**Dealer
Service
Bulletin**

NO.: 7SB002-24-02A

SUBJECT: Rear Cap Installation

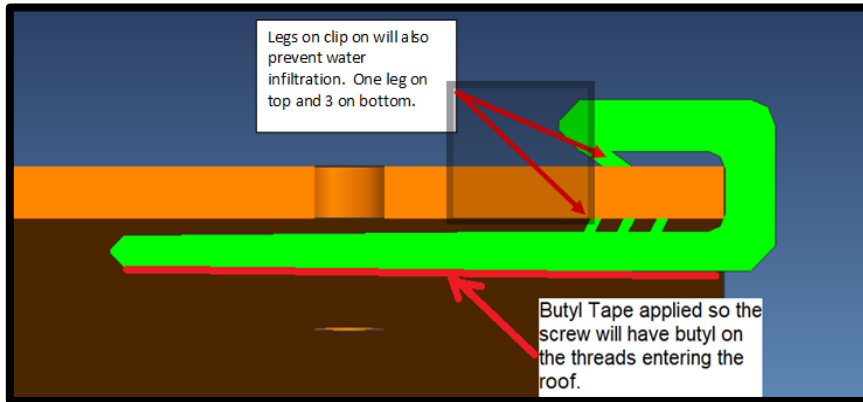
This bulletin is to advise you of a change to the rear cap installation process. We have eliminated the need for self-leveling sealant on the front edge of the rear cap in favor of a clip-on rubber seal. This will eliminate complaints of sealant voids and cracks in this area.

Please be sure to pass this along to your staff so they are aware that the area is not missing sealant. Reference photos below.
